**RE: 8901 Modesto Ave NE**  
**Grading and Drainage Plan**  
**Engineer's Stamp Date: 9/19/2025**  
**Hydrology File: B20D072**  
**Case # HYDR-2025-00358**

Based upon the information provided in your submittal received 10/03/2025, the Grading & Drainage Plan is **not** approved for Building Permit. The following comments need to be addressed for approval of the above referenced project:

**8901 MODESTO**

**GRADING PLAN**

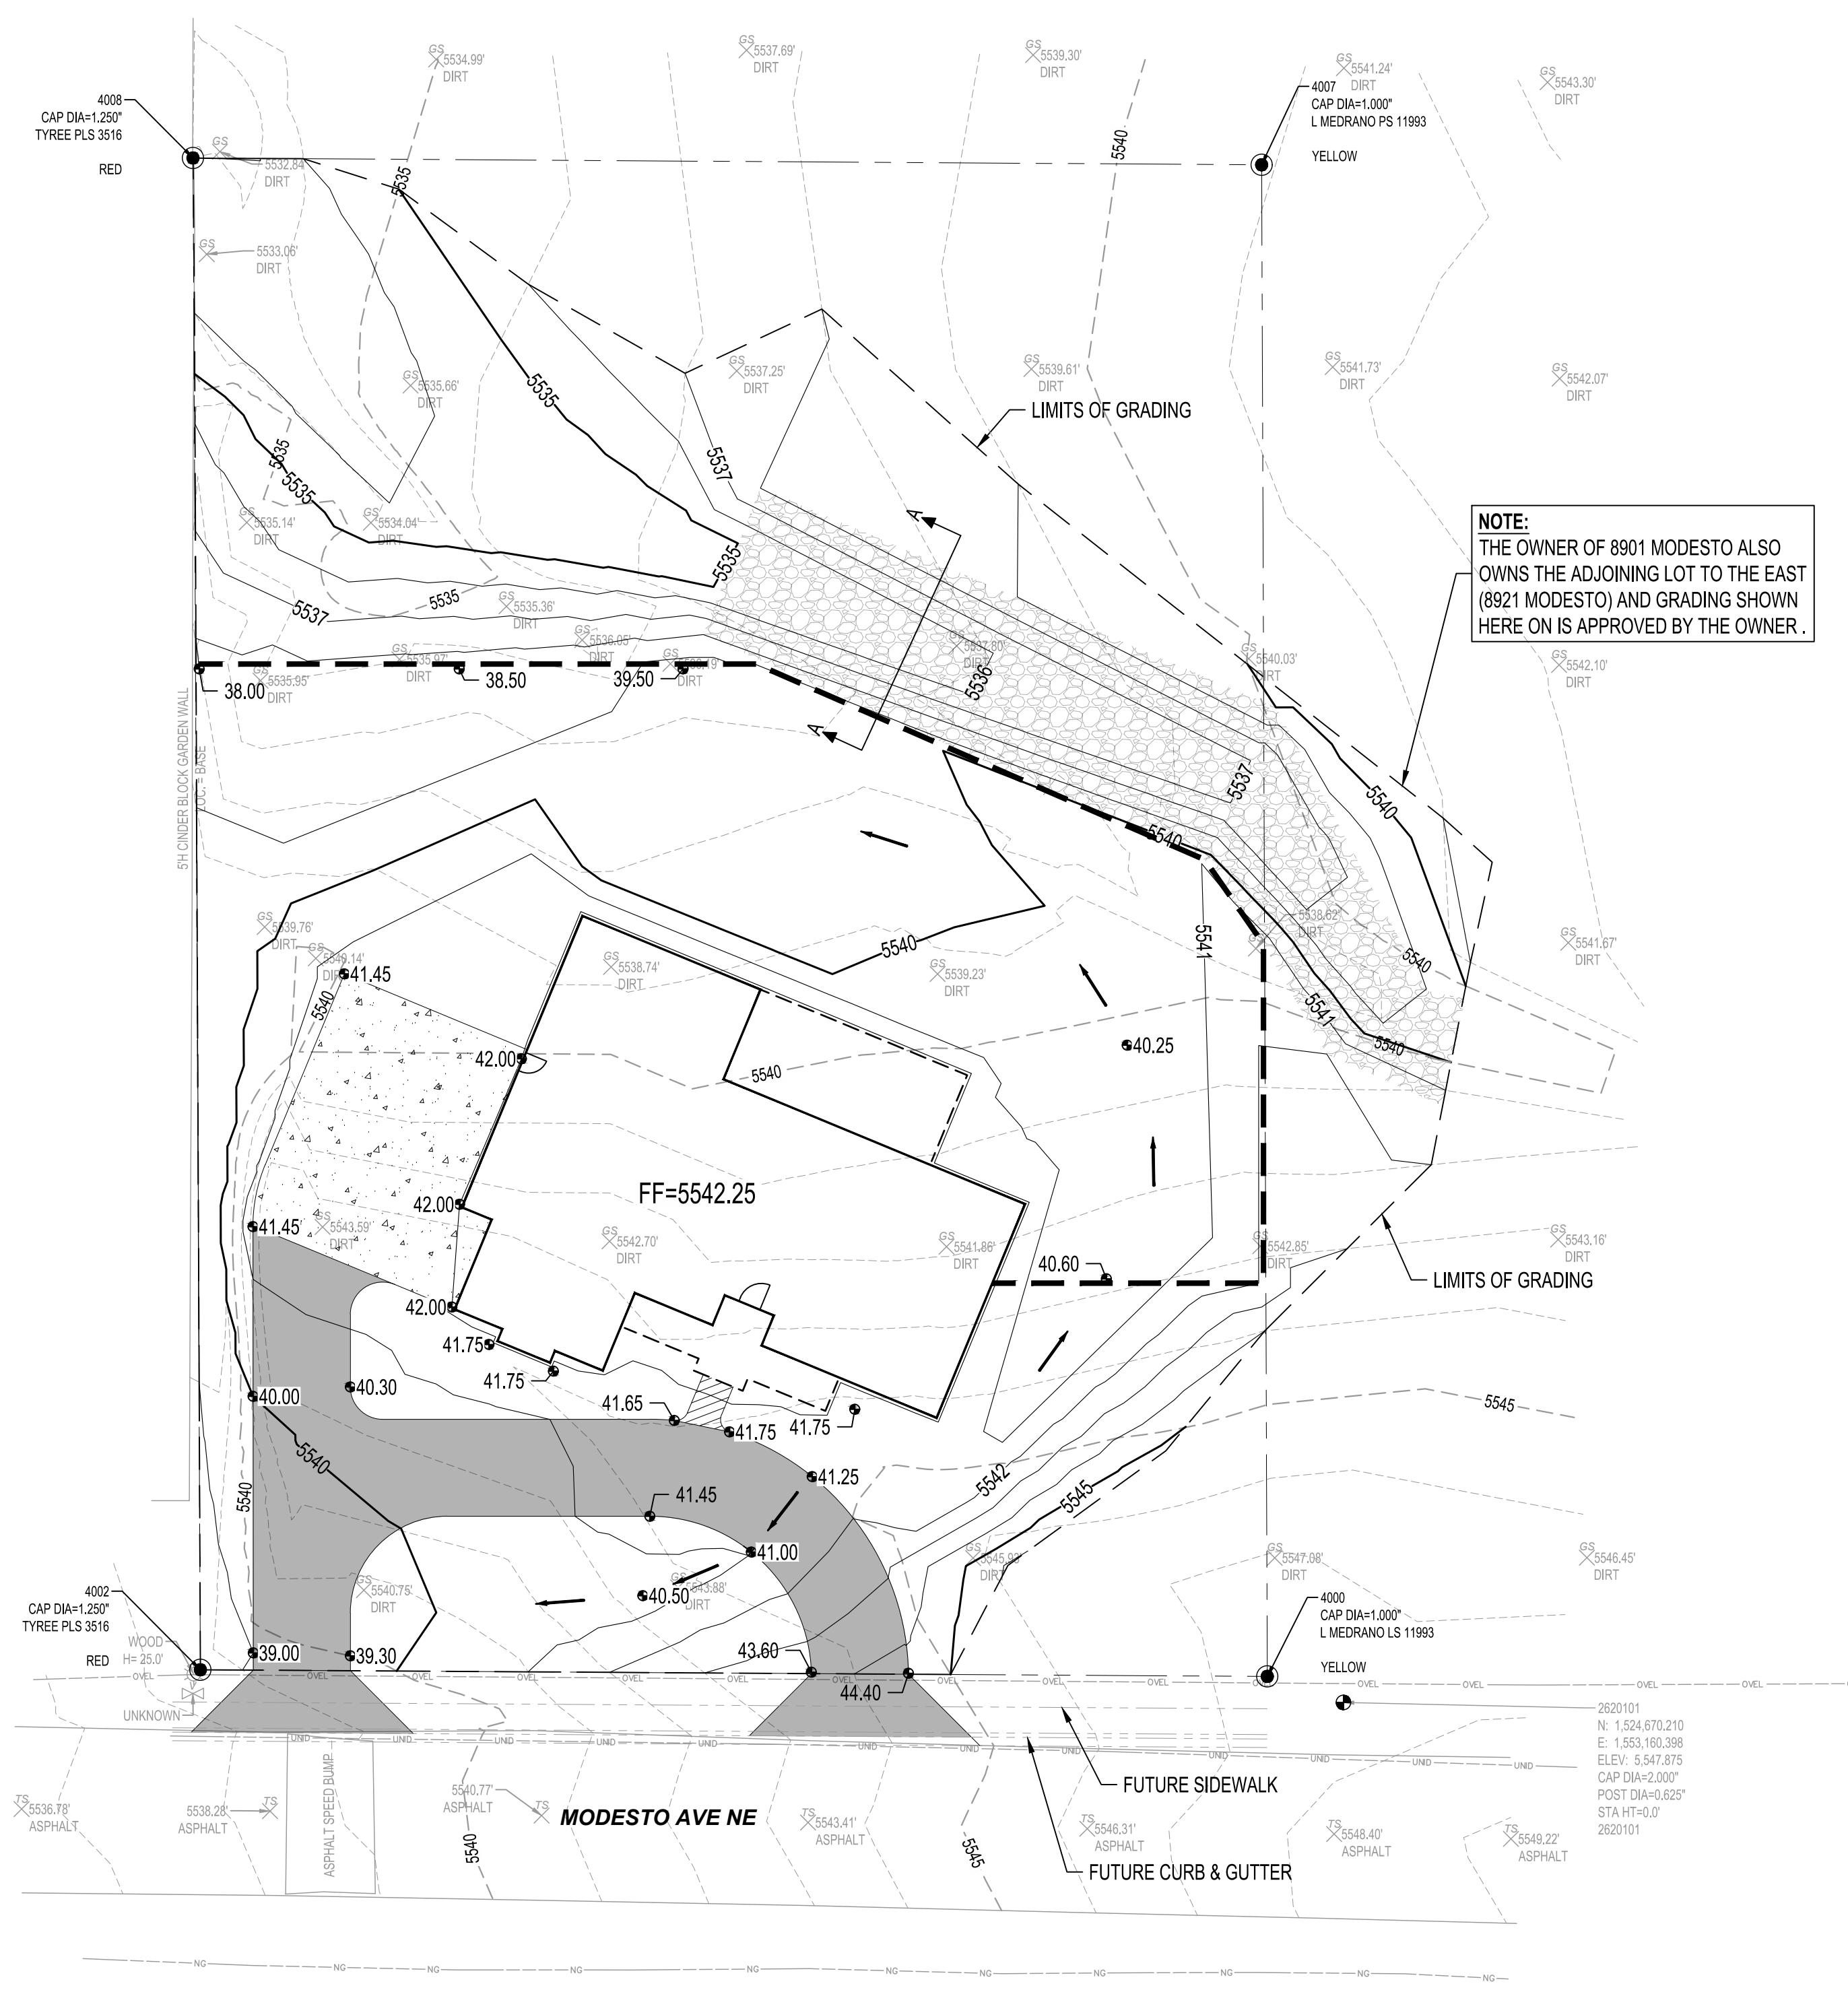
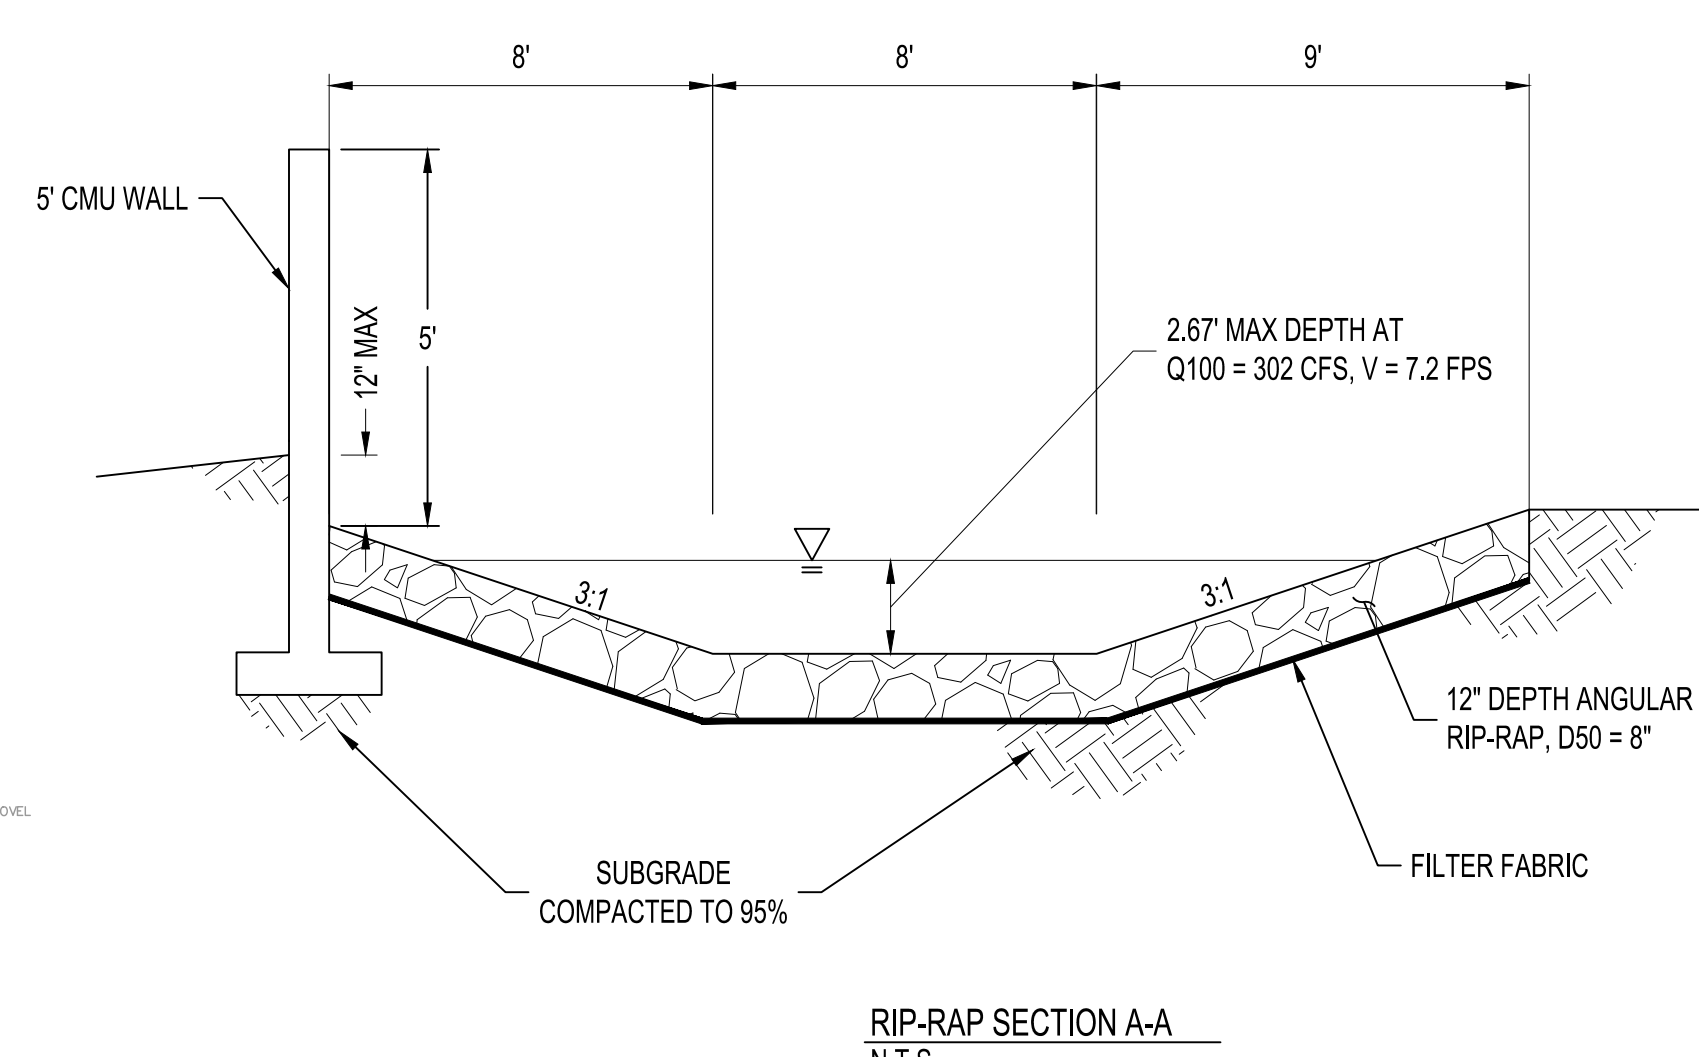
1. Per the DPM, the following must be on the Grading Plan. Please note the Grading Plan must be a stand-alone construction document.
  - a. Please provide a licensed New Mexico civil engineer's stamp with a signature and date.

- b. Please provide the FIRM Map and flood plain note with effective date.
2. Provide management onsite for the Stormwater Quality Volume (SWQV) in accordance with the new drainage ordinance, § 14-5-2-6 (H). Please show the top and bottom of the ponds along with the volume for each pond. The onsite drainage should be directed to these ponds prior to being collected in a private underground drainage system. Please follow the DPM Article 6-12 Stormwater Quality and Low-Impact Development for the sizing calculations. To calculate the required SWQV, multiply the impervious area draining to the BMP by 0.42 inches for new development sites and 0.26 inches for redevelopment sites. The calculations of both the required and the provided volume of each BMP must be shown on the Grading and Drainage Plan. Each BMP should be labeled on the Grading and Drainage Plan with the required SWQV and associated water surface elevation and the 100-year water surface elevation. Landscaping of surface BMPs is also required to be noted on the Grading and Drainage Plan.

3. Please provide the SWQV calculations for each basin draining to each pond. The stormwater quality ponds need to be sized for the areas draining to them.
